**Waterfront Barry, Vale
of Glamorgan**

Stage 1 Road Safety
Audit - Designer's
Response

April 2010

2.1 Waterfront Barry Link between Paget Road / Plymouth Road and West Pond / South Quay Junctions (TA Figure 7.7)

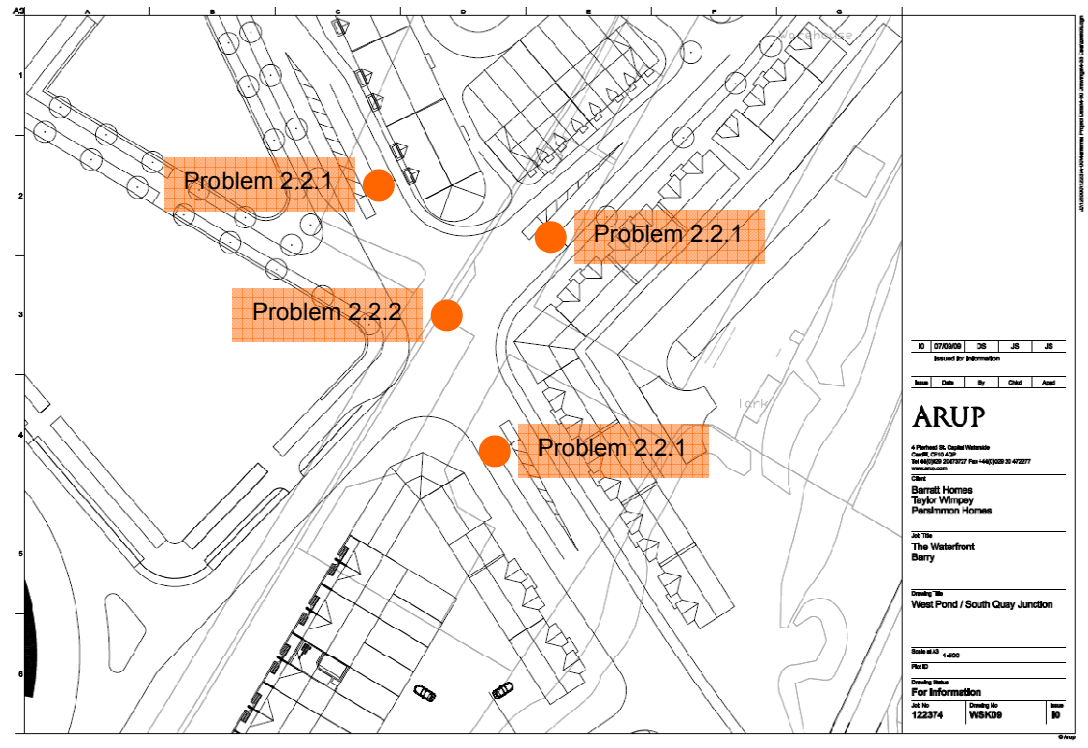
Description The Paget Road / Plymouth Road junction is significantly elevated above the existing dock area.

Steep grades can limit large vehicle's speed leading to frustration and overtaking conflicts.

Recommendation Ensure the grade does not exceed 6% (Waterfront Barry Link will be a bus route), and that vertical curves do not restrict the forward visibility of junctions.

Designer's response Agreed. This will be dealt with in detailed design.

**2.2 Waterfront Barry Link / West Pond / South Quay Junction
 (TA Figure 7.7 Drawing WSK09)**

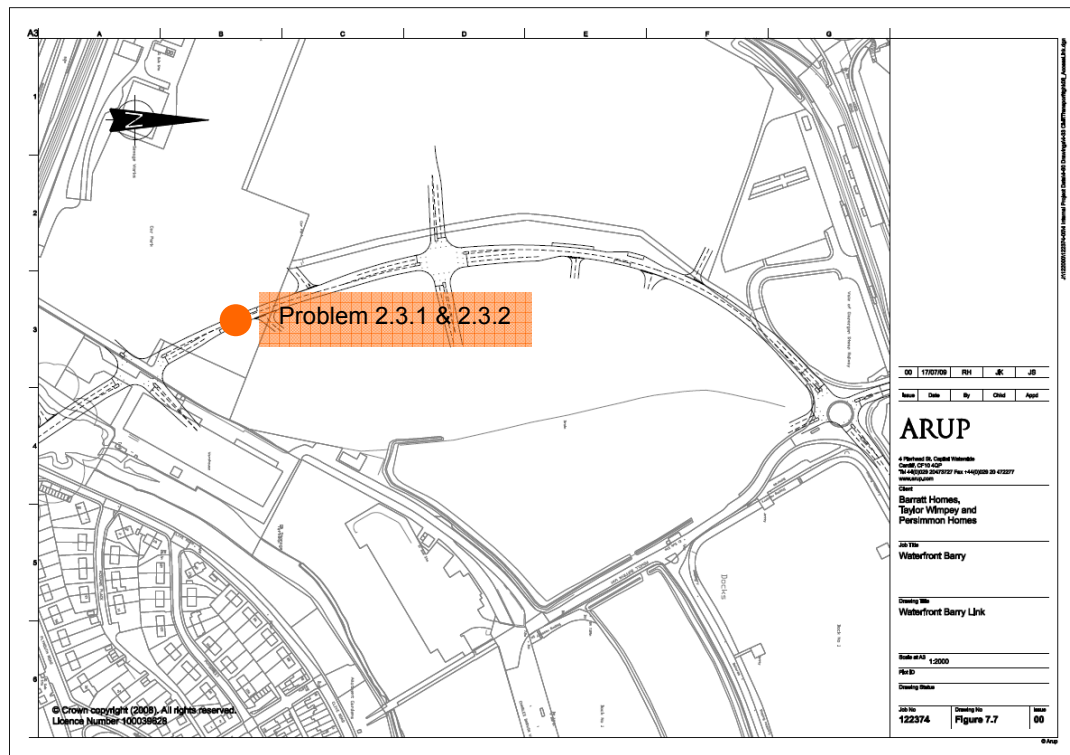
Description The stop lines at the proposed junction are set back a significant distance from the junction centre.

As a result there is a significant distance (approximately 60m) between opposing stop lines resulting in a large expanse of unmarked road surface. This is likely to result in large unused areas promoting the build up of detritus on the carriageway. In addition, some drivers may find the lack of direction here confusing leading to hesitancy.

Recommendation Reduce the size of the junction.

Description The junction layout is such that it promotes an offside right-turning arrangement.

An off-side right-turning (hooking) arrangement can result in blocking during peak periods which can lead to driver frustration and side swipe accidents if vehicles are poorly positioned.

Recommendation Provide additional road markings in the junction as appropriate to assist right turning drivers.

Designer's response Agreed. The position of the stop lines and traffic islands will be brought forward within the limits of the anticipated turning movements. However, consideration will also need to be given to pedestrian crossing movements, which may prevent significant alterations from being made. The design will, if possible, bring forward the traffic islands to include the pedestrian crossings and act as refuges.

Designer's response Agreed. However, the crossing movements may need to remain on the off-side as a result of the overall development layout.

2.3 Waterfront Barry Link between West Pond / South Quay and West Pond / Supermarket junctions (TA Figure 7.7)

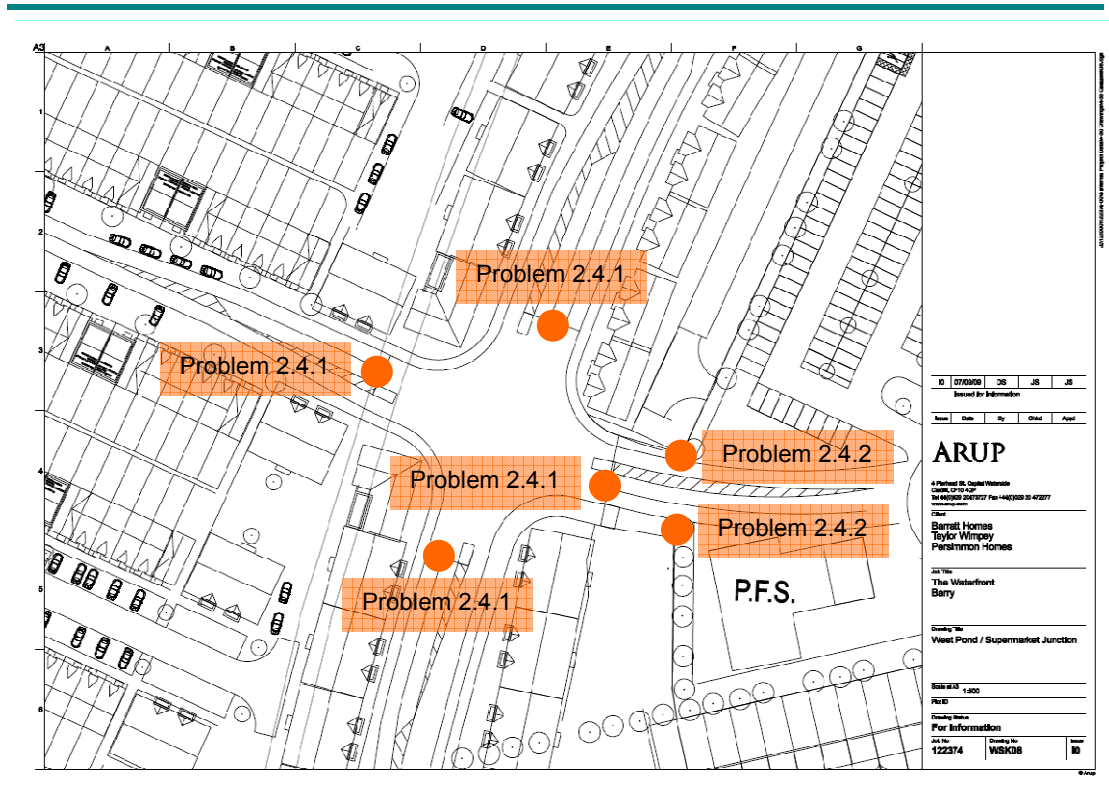
Description The eastbound and westbound bus stops on the southern section of the Waterfront Barry Link are located in close proximity to priority accesses serving residential properties.

The position of the southbound bus stop is within the junction visibility splay, which is likely to result in turning conflicts, whilst the northbound bus stop is located within the junction.

Recommendation Relocate the bus stops away from the junction.

Designer's response Agreed. These will be relocated if possible, but there are intermediate junctions which will limit the amount that the bus stops can be moved, and the locations will need to address the needs of passengers.

**2.4 Waterfront Barry Link / West Pond / Supermarket
 (TA Figure 7.7 , Drawing WSK08)**

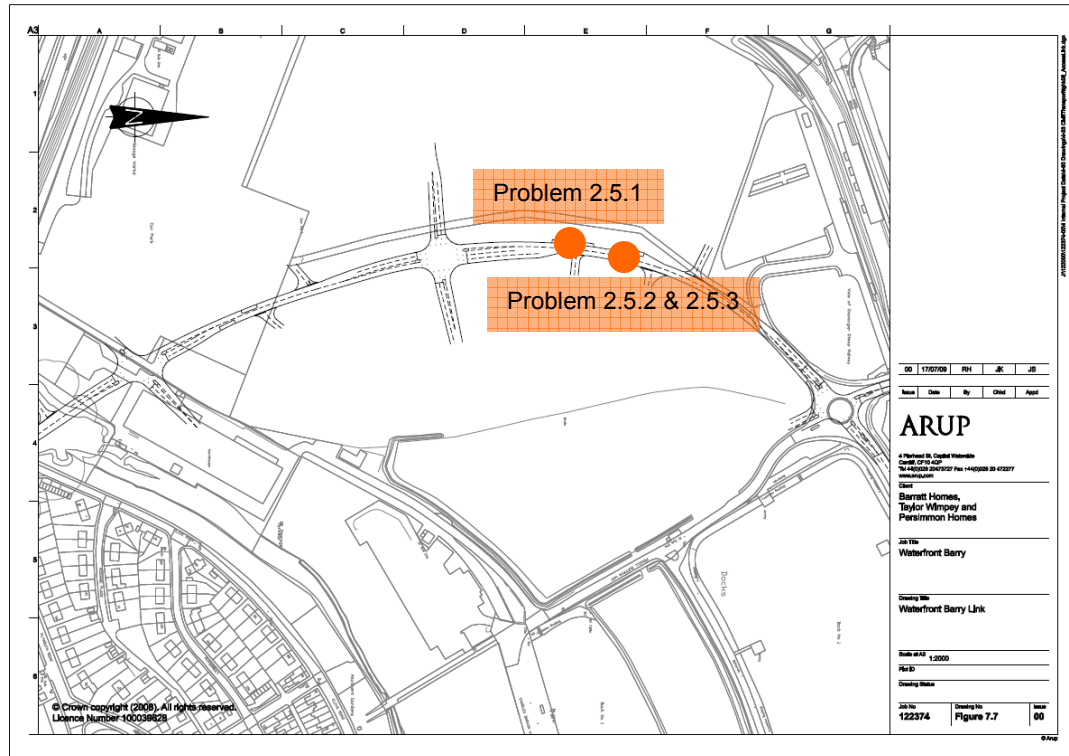
Location	Junction
Summary	Stop line set back
Description	The stop lines at the proposed junction are set back a significant distance from the junction centre. As a result there is a significant distance (approximately 50m) between opposing stop lines, resulting in a large expanse of unmarked road surface. This is likely to result in large unused areas promoting the build up of detritus on the carriageway. In addition, some drivers may find the lack of direction here confusing leading to hesitancy.
Recommendation	Reduce the size of the junction.

Description The proposals show footways on both side of the Supermarket access, however these stop after a short distance.

A lack of pedestrian access from the surrounding residential area will result in pedestrians either using the verge, risking slips and falls, or using the access road at the risk of a collision with a vehicle.

Recommendation Ensure adequate intuitive footway links are provided to the supermarket.

Designer's response Agreed. The position of the stop lines and traffic islands will be brought forward within the limits of the anticipated turning movements. However, consideration will also need to be given to pedestrian crossing movements, which may prevent significant alterations from being made. The design will, if possible, bring forward the traffic islands to include the pedestrian crossings and act as refuges.

Designer's response We agree that this is required. However, the area within the supermarket site will be developed by the supermarket operator and is outside the control of the highways designer.

2.5 Waterfront Barry Link between West Pond / Supermarket West Pond Northern junctions (TA Figure 7.7)

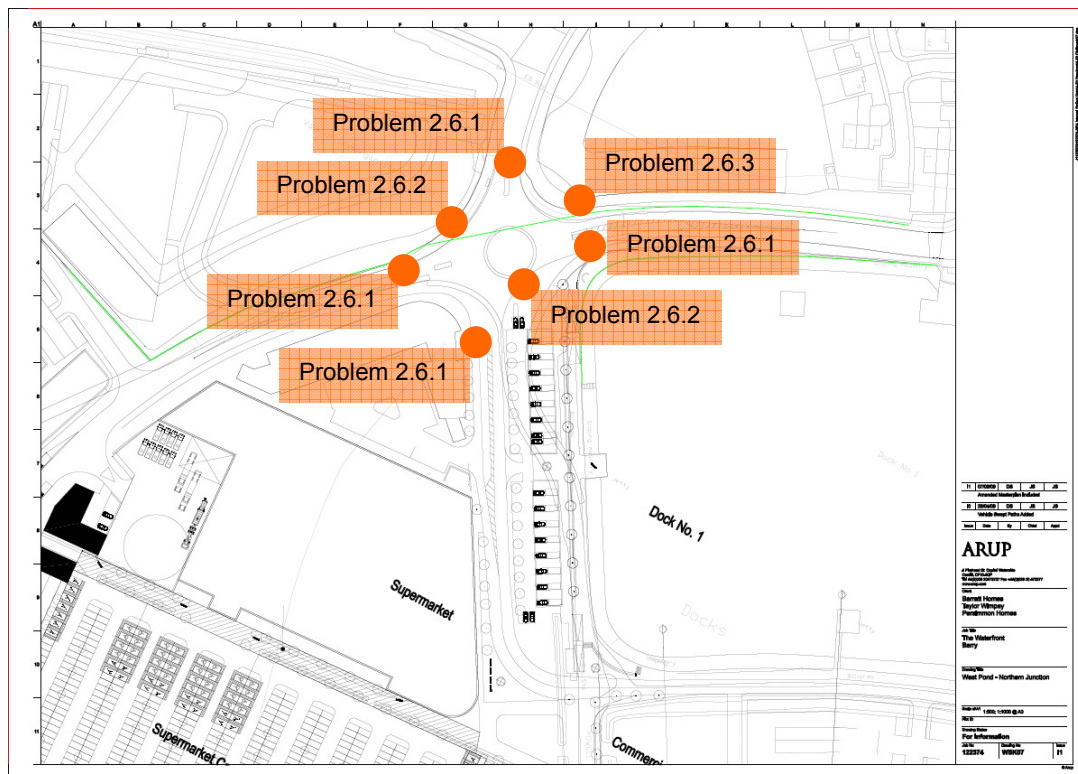
Description The bus stops provided on this section of the link road are located opposite one another, rather than tail to tail.

This is likely to result in a high risk pedestrian crossing path behind and between the buses, placing pedestrians at risk of conflict with passing traffic.

Recommendation Provide a minimum offset of 40 metres to allow traffic to safely pass a stationary vehicle.

Designer's response Not agreed. There is insufficient space to provide this degree of separation. As the northbound bus stop will be positioned within a lay-by, the degree of interaction between bus stops is minimised.

2.6 Waterfront Barry Link / West Pond Northern Junction (TA Figure 7.7 , Drawing WSK07)

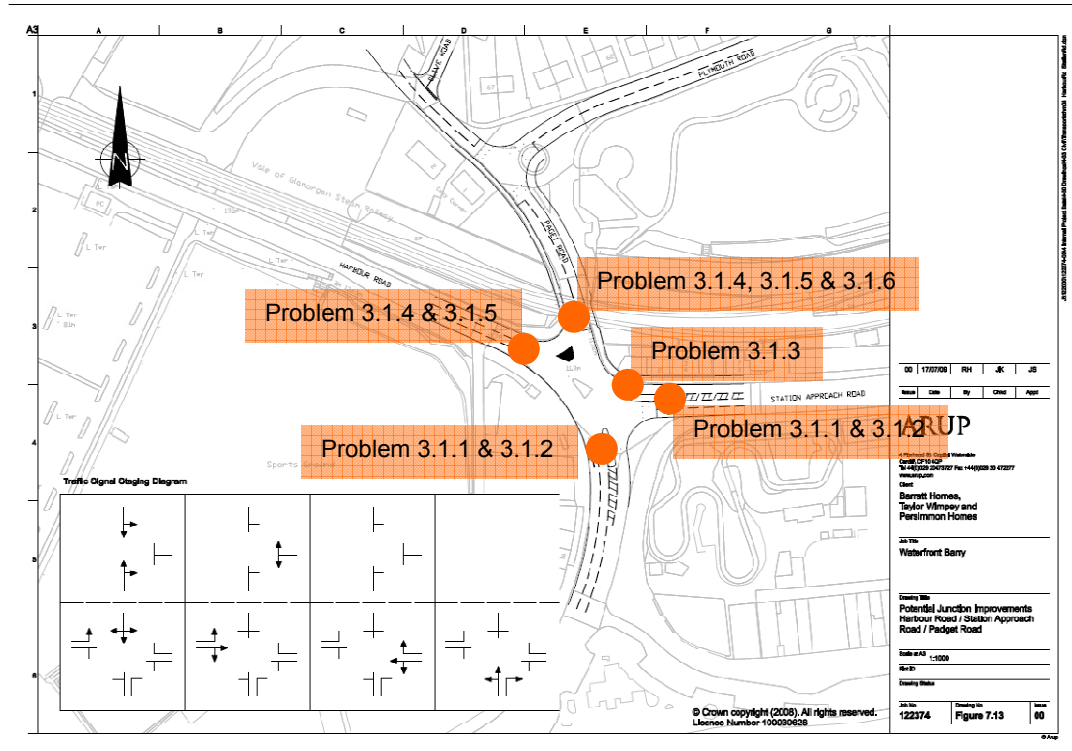
Description The stop lines at the proposed junction are set back a significant distance from the junction centre.

As a result there is a significant distance (approximately 70m) between opposing stop lines, resulting in a large expanse of unmarked road surface. This is likely to result in large unused areas promoting the build up of detritus on the carriageway. In addition, some drivers may find the lack of direction here confusing leading to hesitancy.

Recommendation Reduce the size of the junction.

Description The junction has been provided with sweeping radii particularly in the north western and south-eastern corners.

Sweeping radii can result in high entry speeds, leading to loss of control on the exit.

Recommendation Reduce the junction radii to reduce traffic speeds within the junction.

Description It is not clear from the proposed arrangement how National Cycle Route 88, currently running alongside the existing junction is to be accommodated.

Cyclists are particularly vulnerable to side swipes at junctions and could be struck while crossing at splitter islands not specifically designed to accommodate them.

Recommendation Include measures to assist cycles at the junction.

Designer's response Agreed. The position of the stop lines and traffic islands will be brought forward within the limits of the anticipated turning movements. However, consideration will also need to be given to pedestrian crossing movements, which may prevent significant alterations from being made. The design will, if possible, bring forward the traffic islands to include the pedestrian crossings and act as refuges.

Designer's response Not agreed. The radii are commensurate with the required vehicle turning paths for a marina facility at the request of the local authority.

Designer's response Agreed. This will be dealt with in detailed design.

3.1 Harbour Road / Station Approach / Paget Road (TA Junction 08 Figure 7.13)

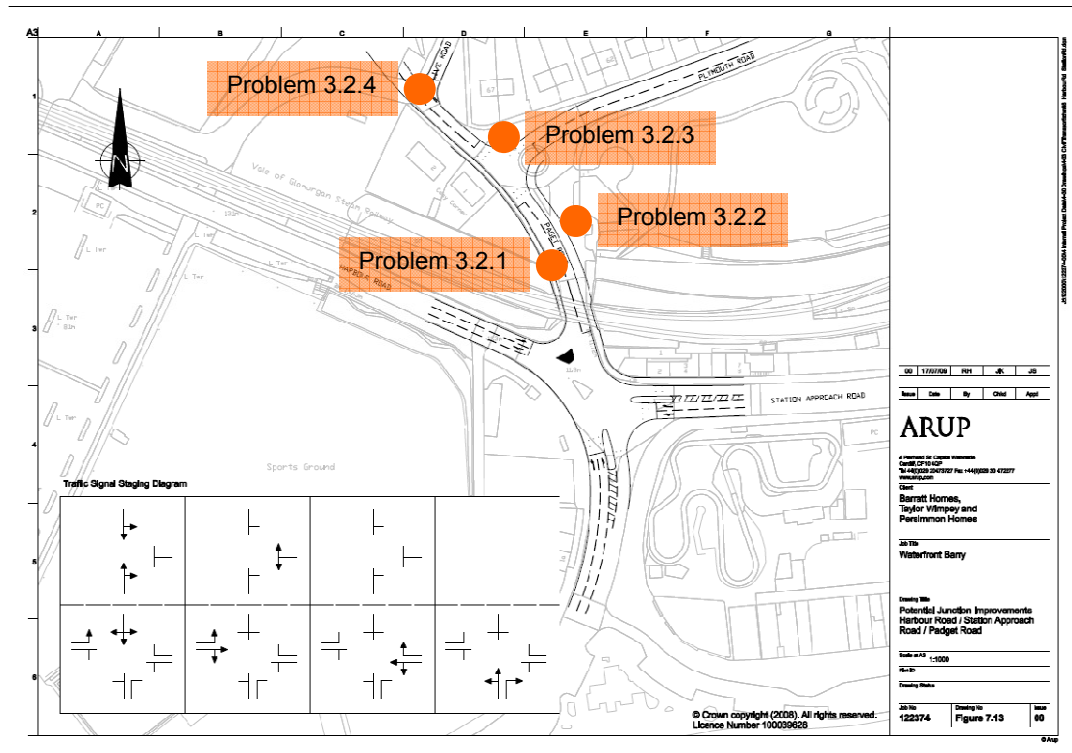
Description The crossings proposed on the southern and eastern arms of the junction have right-left staggers.

The right-left stagger results in pedestrians approaching the second half of the crossing, facing away from oncoming traffic. This could result in a pedestrian continuing to cross, oblivious to oncoming traffic.

Recommendation Provide the crossings with a left-right stagger.

Description Due to the phasing of the junction, there will only be limited opportunity to cross the southern and eastern arms of the junction.

Recommendation Consider an all red crossing arrangement of this junction.

Description The exit arm on Station Approach has a narrow throat as a result of the proposed splitter island.

Recommendation Assess the junction using AutoTrack to ensure there is adequate carriageway width for large vehicles.

Description Pedestrian crossing facilities are not proposed on the northern or western sides of the junction.

Recommendation Consider an all red crossing arrangement of this junction.

Description The Paget Road arm of the junction runs under a railway bridge in the immediate vicinity of the junction. As a result drivers will emerge from the shadow of the bridge as they meet the traffic signals.

As a result the signals may be difficult to see, especially in bright or low winter sun conditions, leading to overrunning of the stop line.

Description Paget Road is a bus route and buses currently struggle to turn from Harbour Road without encroaching on the southbound lane. The proposed kerb line will narrow the exit arm.

This could result in sideswipe or even head on collisions on this arm of the junction.

Designer's response The provision of left-right staggers will be investigated. However, this is likely to set back the proposed stop-lines at the junction, so reducing its efficiency.

Designer's response This will be considered during detailed design. And included providing that sufficient vehicle capacity can be achieved.

Designer's response Agreed. The junction was originally sized using AutoTrack on the ordnance Survey background. Tthis will be re-checked against the topographical during detailed design and adjusted if necessary.

Designer's response This will be considered during detailed design. However, this will reduce the efficiency of the junction.

- Recommendation** Provide backing boards on the traffic signal heads in order to maximise visibility.
- Designer's response** Agreed.

- Recommendation** Ensure the lane markings provided on Paget Road can accommodate buses turning from Harbour Road.
- Designer's response** Agreed.

3.2 Paget Road / Plymouth Road (TA Junction 22 Figure 7.13)

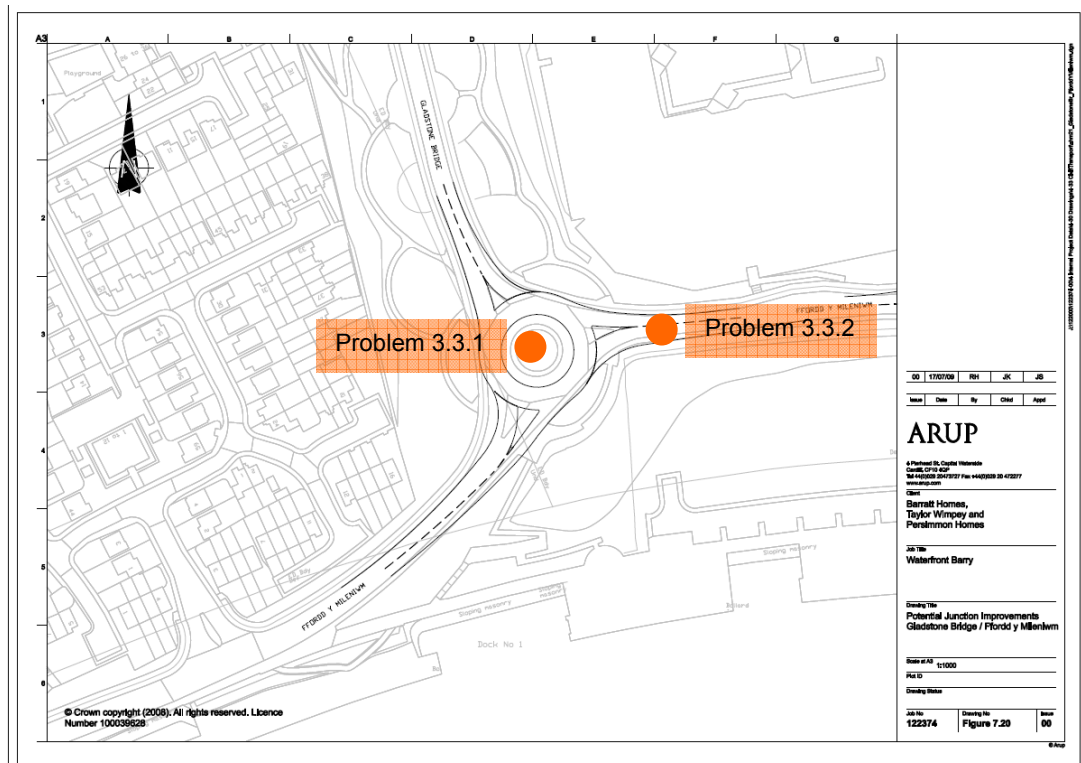
Description Road markings presently directing visitors to the car park are not shown on the proposed road layout.

A lack of adequate direction signing could result in drivers entering the residential streets of Barry Island leading to unnecessary congestion and conflict.

Recommendation Provide appropriate traffic signing and/or road markings to guide visitors to the car park.

Description The maintenance access to Maslin Park from Paget Road is not maintained in the proposed road layout.

Recommendation Ensure adequate access is maintained for the park.

Description There are several properties set around the junction area where, despite parking restrictions, kerbside parking occurs. It is proposed to enlarge the footway in this area which may be attractive for parking.

Recommendation Introduce deterrent measures to prevent footway parking around the junction.

Description Clive Road has a steep grade, and the proposals introduce a priority junction at the foot of the grade.

Recommendation Provide speed reduction measures and high friction surfacing on the Clive Road approach to the Waterfront Barry Link

Designer's response Vehicular access to the existing car park is proposed elsewhere.

Designer's response Agreed

Designer's response We agree this is a problem. However, this is an illegal activity and enforcement is not the responsibility of the developer.

Designer's response Agreed.

3.3 Gladstone Bridge / Ffordd y Mileniwm (TA Junction 21, Figure 7.20)

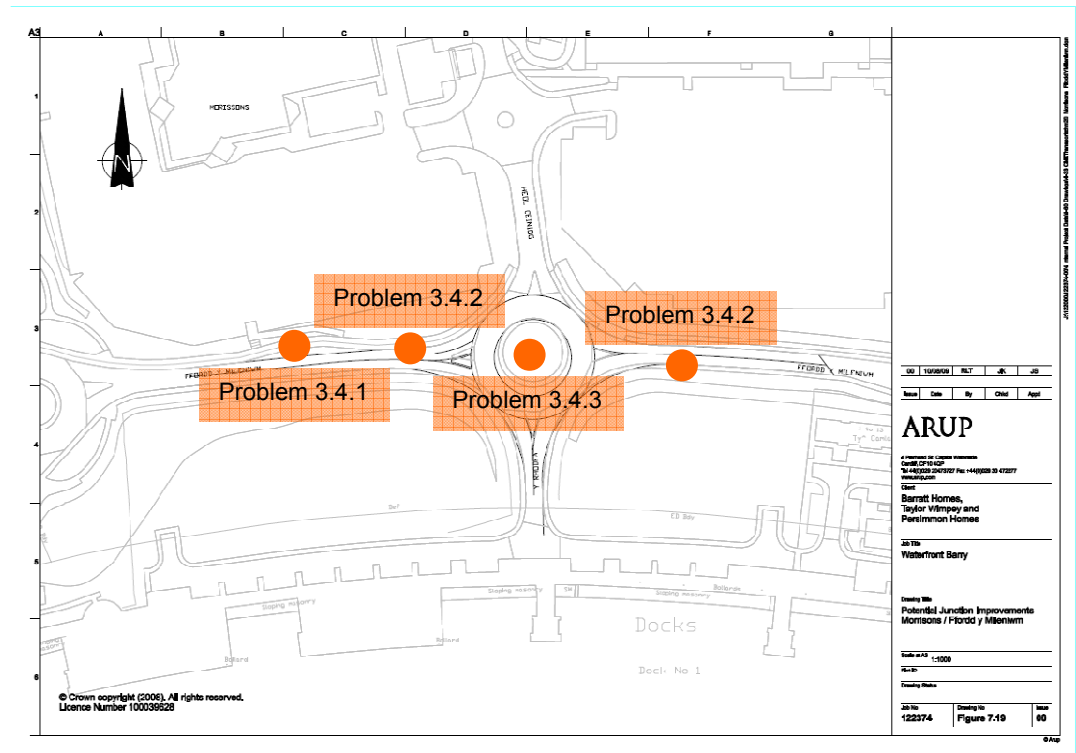
Description There is an excessive amount of vegetation and hard landscaping on the circulatory island of the roundabout

Excessive landscaping blocks visibility for all road users, especially pedestrians who cannot see approaching vehicles, whilst hard landscaping can present a hazard for errant vehicles.

Recommendation Remove the vegetation and hard landscaping.

Description The proposed alteration to the junction layout results in an increase in the deflection radius of in the westbound approach of Ffordd y Mileniwm.

Insufficient entry deflection can lead to inappropriate entry speed into and around the junction, resulting in overrunning of the give-way lines, conflicts within the circulatory carriageway, and loss of control accidents, especially on the exit arms.

Recommendation Alter the junction layout in order to provide sufficient entry deflection.

Designer's response The excess vegetation can be removed with the agreement of the Planning and Highway Authorities. As the roundabout is altered, anew planting regime will need to be established.

Designer's response Not agreed. Although there is a small increase in the approach radius, this has been checked and the radius is still less than 100m. This is within standards for the roundabout.
